Technical Bulletin

Eagle Single Pilot and Copilot Lighting Upgrade

Bell 212

TBN-212-004

Figure 4 – TBN-212-004-013 Wiring Diagram

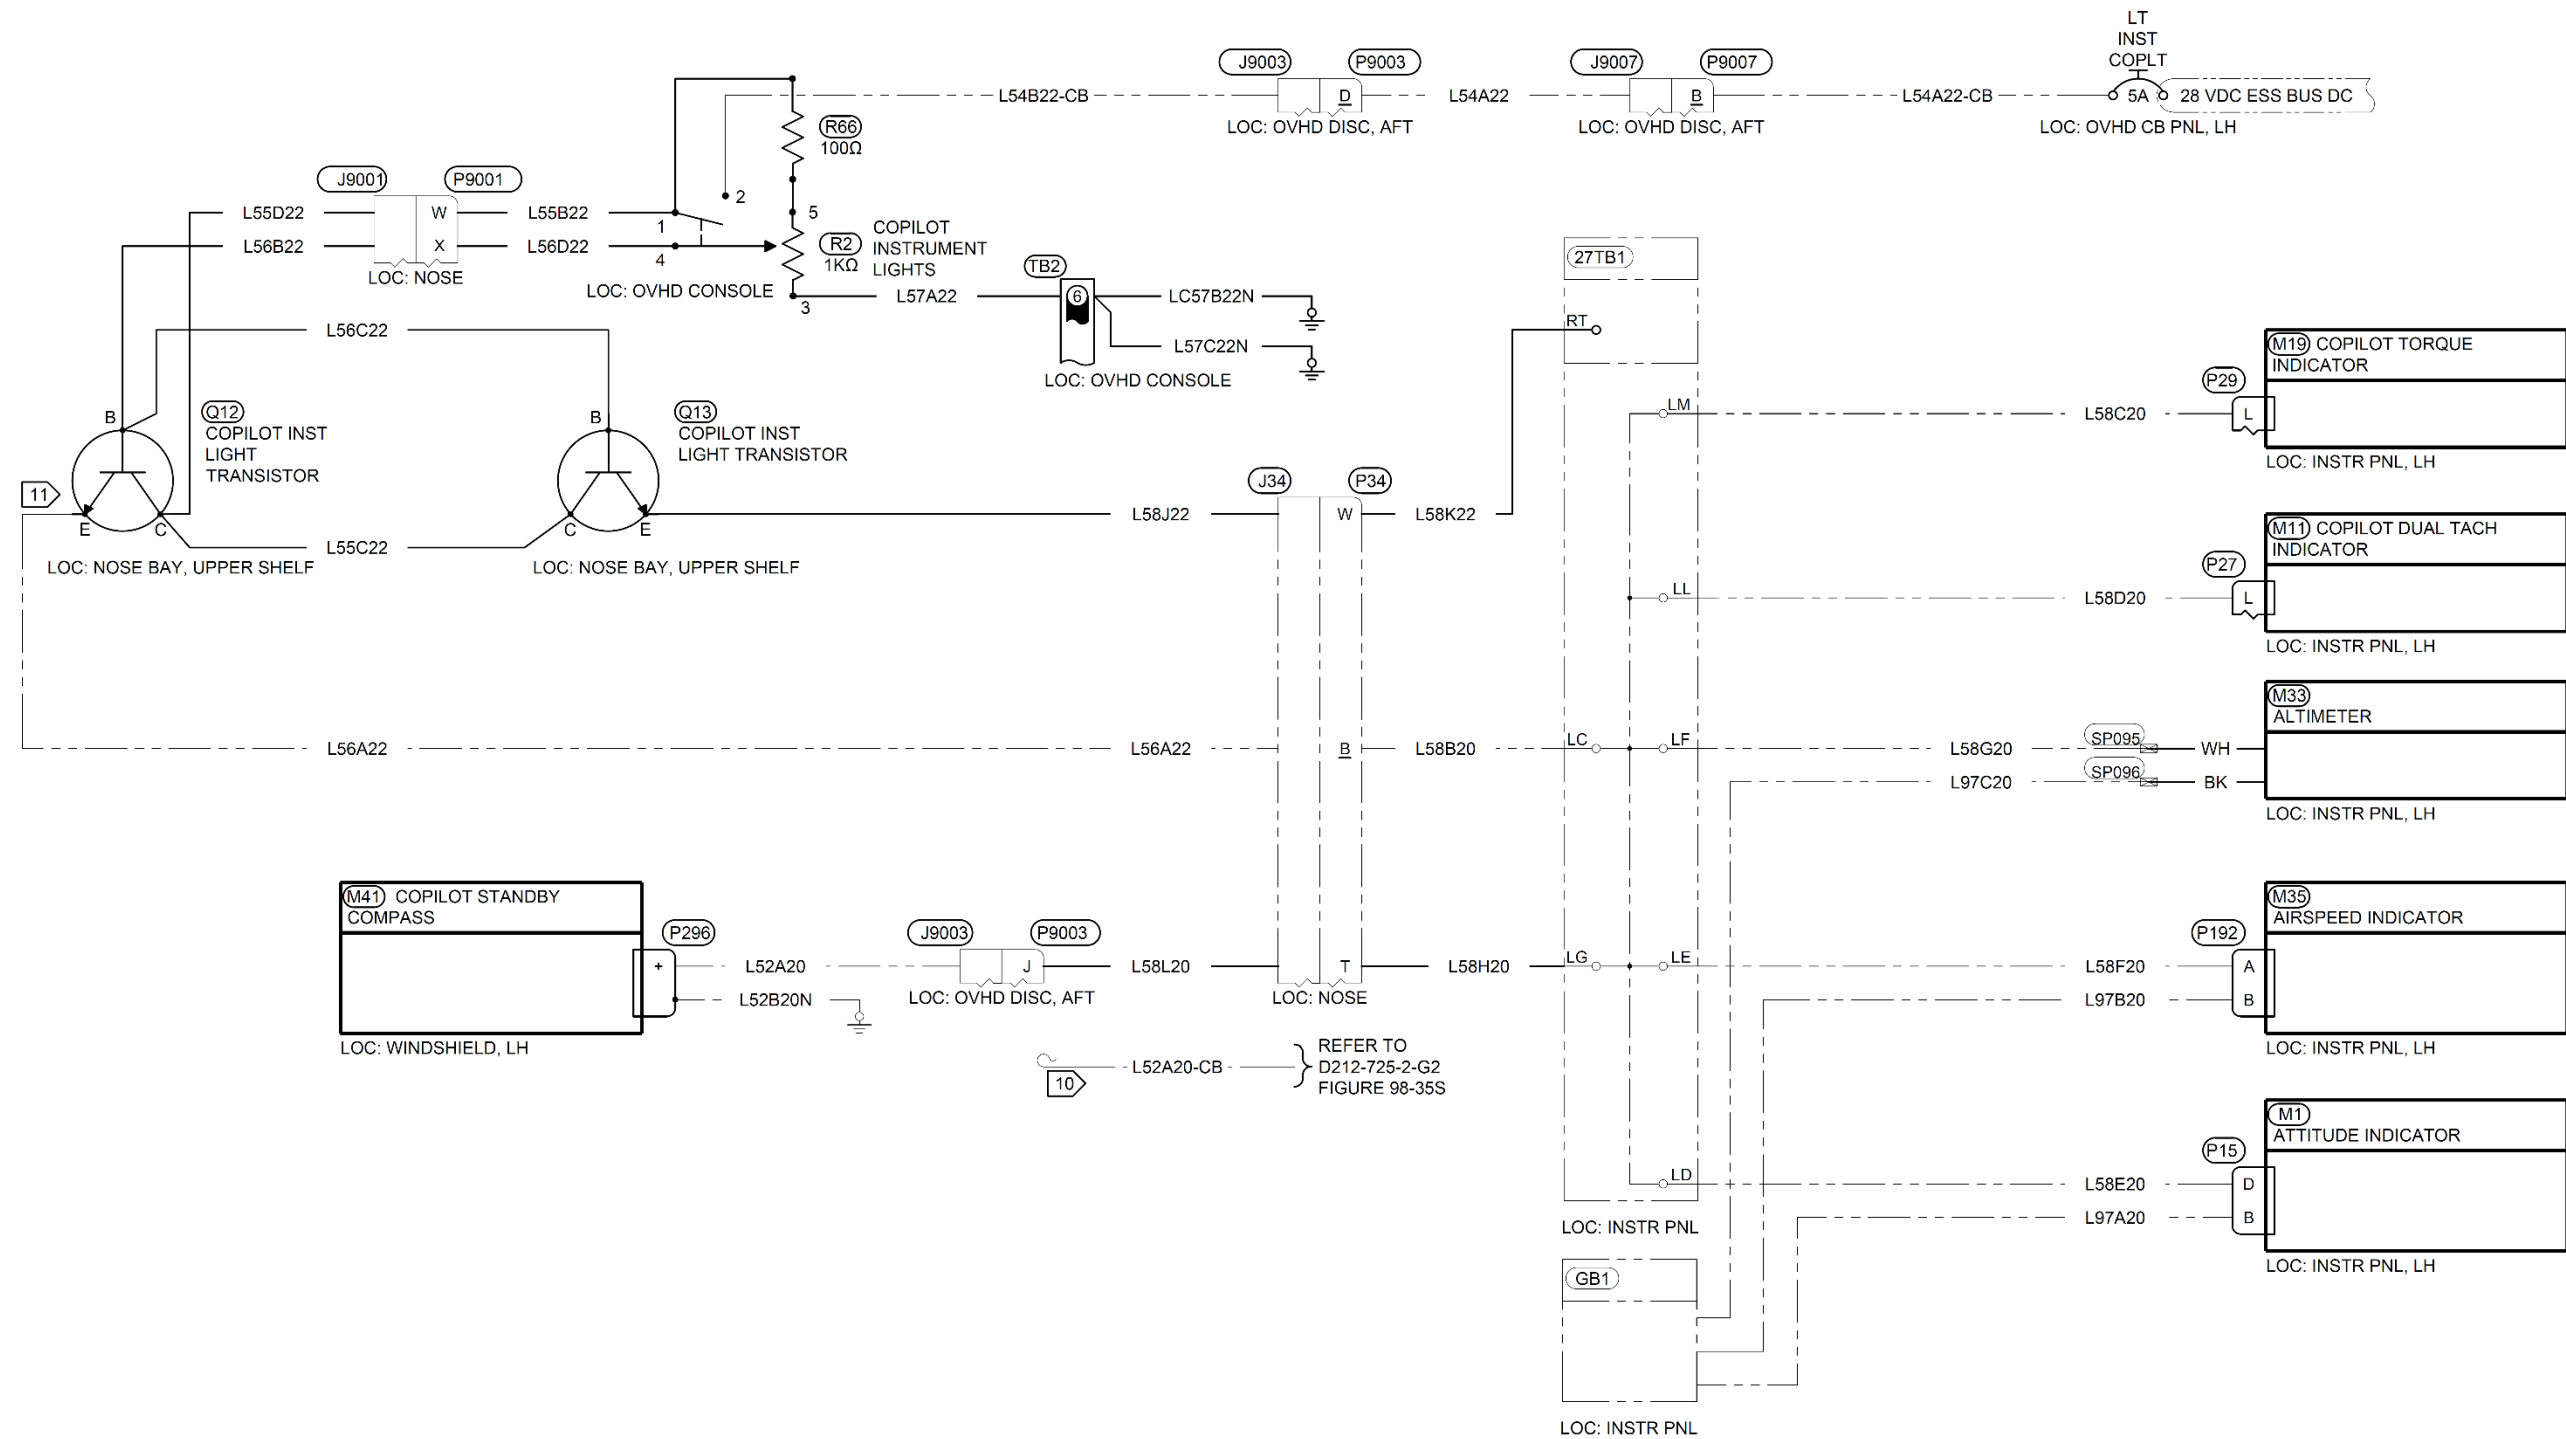
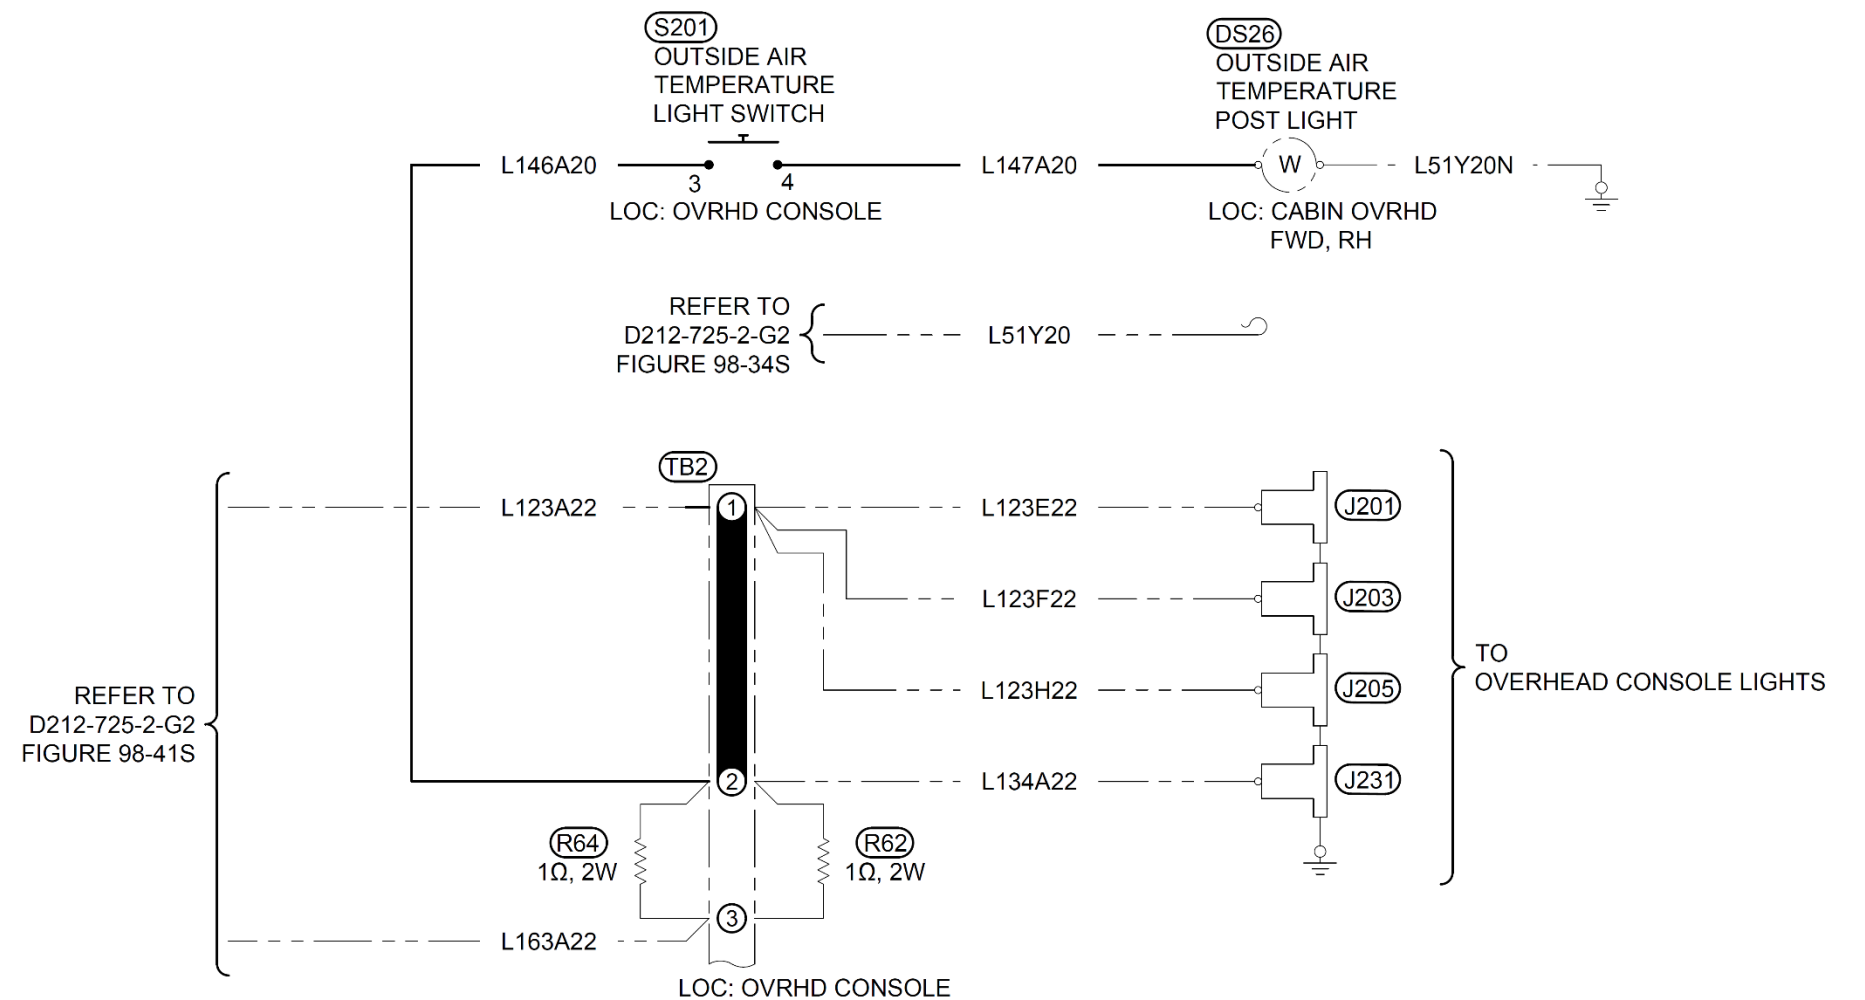
6. From the Overhead Circuit Breaker Panel, Rheostat R1, route and terminate wires to TB3 and P9001 as shown on Figure 4, sheet 1.
7. Install Resistor R65 as shown on Figure 4, sheet 1.

8. From connector J9001, route and terminate wires to the transistor, Q10 as shown on Figure 4, sheet 1.
9. From transistor, Q10, route and terminate wires to the transistor Q11 as shown Figure 4, sheet 1.

10. From transistors, Q10 and Q11, route and terminate wires to the connector, J33 as shown on Figure 4, sheet 1.
11. From connector P33, route and terminate wire to the terminal module, 27TB1 as shown on Figure 4, sheet 1.

12. From the Overhead Circuit Breaker Panel, Rheostat R2, route and terminate wires to TB2 and P9001 as shown on Figure 4, sheet 2.
13. Install Resistor R66 as shown on Figure 4, sheet 2.

14. From connector J9001, route and terminate wires to the transistor, Q12 as shown on Figure 4, sheet 2.
15. Extract L56A22 from the connector, J9001 pin N, relocate and terminate L56A22 to the transistor, Q12 as shown on Figure 4, sheet 2.

16. From transistor, Q12, terminate wires to the transistor, Q13 as shown on Figure 4, sheet 2.
17. From transistors, Q13, route and terminate wire to the connector, J34 as shown on Figure 4, sheet 2.

18. On the Overhead Disconnect P9003, extract and cap and stow wire L52A20-CB as shown on Figure 4, sheet 2.
19. Route and terminate wire L58J20 from the Overhead Disconnect P9003 to the connector, J34 as shown on Figure 4, sheet 2.

20. From connector P34, route and terminate wires to the terminal module, 27TB1 as shown on Figure 4, sheet 2.

23. From the Outside Air Temperature Post Light, DS26, route and terminate wire L147A20 to the Outside Air Temperature Light Switch, S201 as shown on Figure 4, sheet 3.

24. From the Outside Air Temperature Light Switch, S201, route and terminate wire L146A20 to the Terminal Board, TB2 as shown on Figure 4, sheet 3.
25. Access Overhead Circuit Breaker Panel left and right hand side in accordance with Bell Maintenance Manual BHT-212-MM.

Figure 5 – O.A.T Light Switch

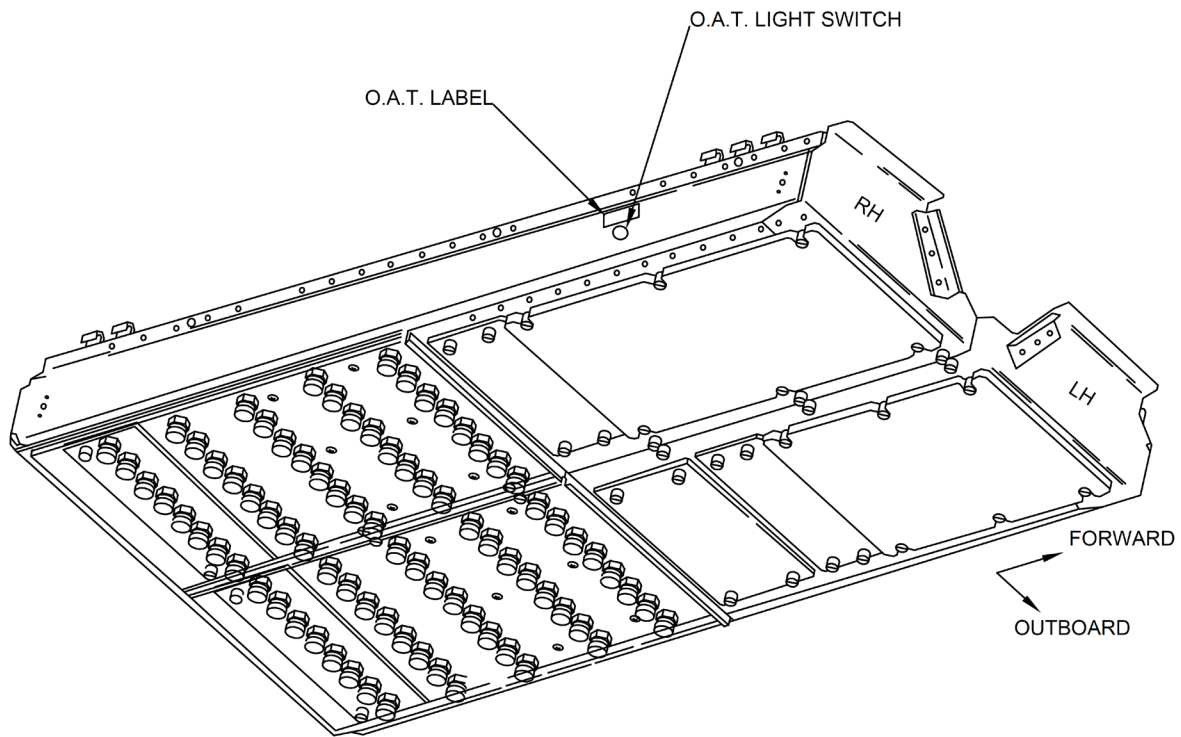
22. If required, route and terminate wire L58H20 from connector, P34 to terminal module 27TB1 as shown on Figure 3, sheet 2.
23. Install S201 Outside Air Temperature Light Switch on the Overhead Console as shown on Figure 5.

21. Install S201 Outside Air Temperature Light Switch on the Overhead Console as shown on Figure 5.
22. From the Outside Air Temperature Post Light, DS26, extract and cap and stow wire L51Y20.
